MASTER DEVELOPMENT PLAN

SUNDANCE SUBDIVISION  
KB HOME  
4800 FREDERICKSBURG ROAD  
SAN ANTONIO, TEXAS 78229

Re: Sundance Subdivision (Amendment)

MDP # 820- A

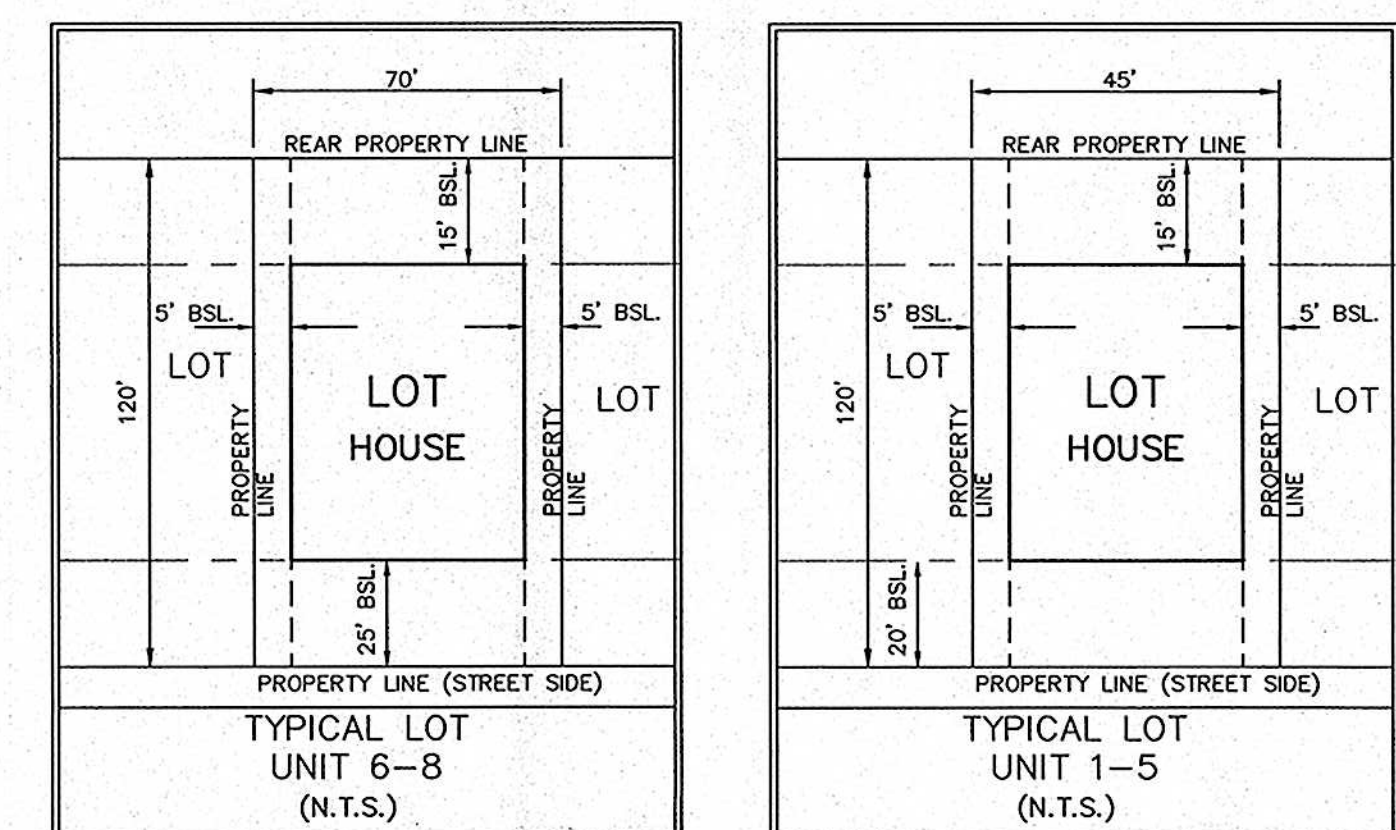
- In consideration of public safety and convenience, excessive grades by reason of topography should be avoided in street layouts and arrangements.
- Any access and R.O.W. issues along state facilities will need to be resolved with the Texas Department of Transportation (TXDOT). For information about these requirements you can contact TXDOT at 615-5814.

1. The above referenced MDP is approved with the following conditions:
    - a. Resolve the intersection issue between Sundance Walk & Star Glade in Unit 1. UDC Section 35-506(f) states that "the centerline offset of intersections shall be at least 175 feet.

- b. Add a note stating that all intersections shall comply with clear vision area requirements in accordance with UDC Section 35-506(d)(5).
    - c. It appears that the cul-de-sac in Unit 4 is greater than 500 feet in length, so it will require a turnaround right-of-way of 120 feet in diameter.

- d. Show sidewalks on Potranco Road and connecting sidewalks at both entrances.

- **Storm Water Engineering** has reviewed the Sundance (MDP) Master Development Plan submittal and comments are as follows: Be advised that the FEMA FIRM 100-year floodplain is inundating proposed lots on the Master Development Plan. This area will require a letter of Map Revision or Conditional Letter of Map Revision at the time of platting.
